APPENDIX C
BICYCLE / PEDESTRIAN
ASSESSMENT

**Bicycle and Pedestrian Review
US 31W (Louisville Road) Scoping Study
Old Porter Pike (MP 16.558) to KY 957 (Plum Springs Loop
Road) (MP 18.084)
Warren County**

Prepared by:
Troy Hearn
Division of Planning
Kentucky Transportation Cabinet
August 19, 2015

Figure 2 /

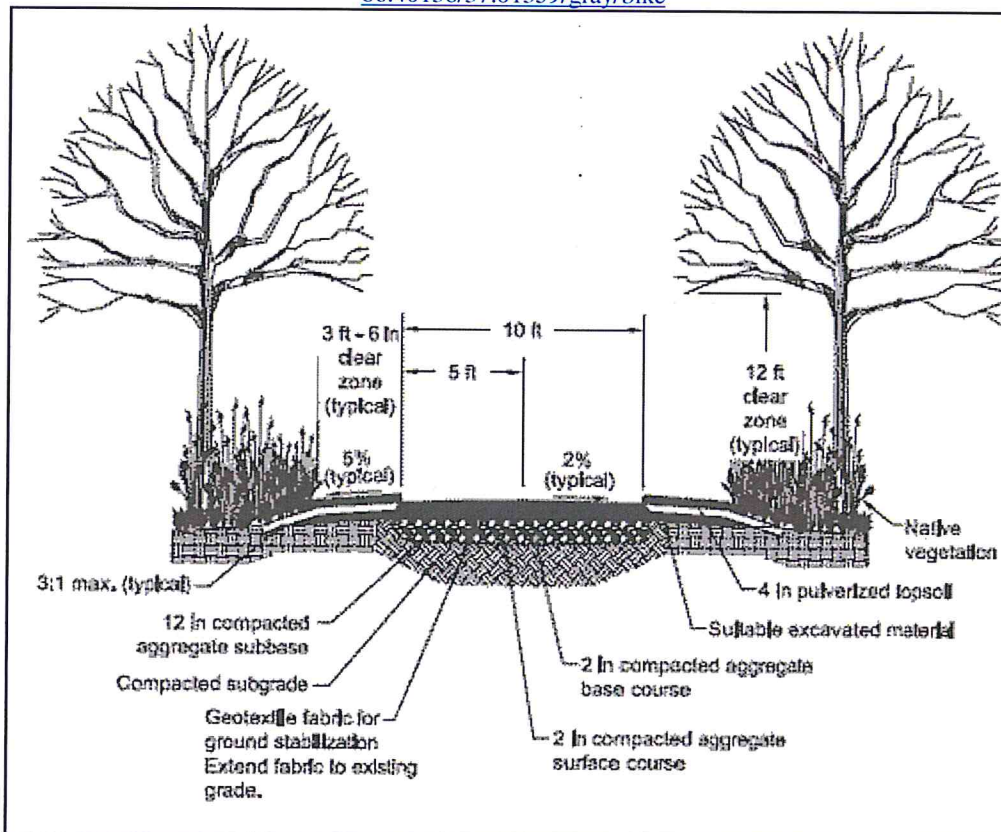
Construct a 10 ft (or wider) shared use path (Figure 2) along the south eastern section of US-31W (entire length of project). This would provide a safer and more complete connection to the proposed greenways system (Figure 3), Weldon Peete Park, Commercial businesses, and current routes (Figure 3) to outlying rural secondary roads used by recreational road cyclists. This would provide a linkage to the already planned shared use path with project # 3-199.00. This would serve both pedestrians and cyclists. This would improve the BCI to A for this section of roadway.

Figure 4 / FHWA Rumble Strip Guidance

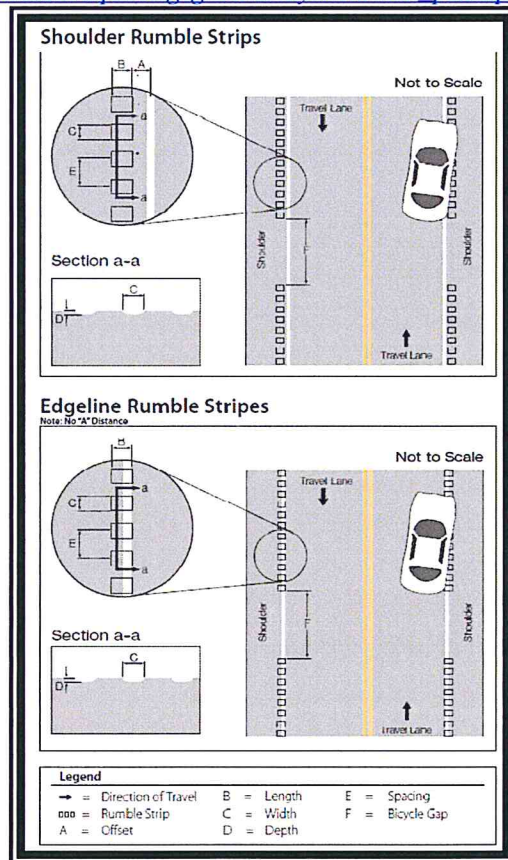
Construct an 8 foot or wider shoulder and provide a 10 foot gap space in the rumble strip every 40 feet (figure 4). This would improve the BCI to a D. Construct a sidewalk (5 ft or wider) on the south eastern section of US-31W for the entire length of the project. Provide crossings at all signalized intersections.
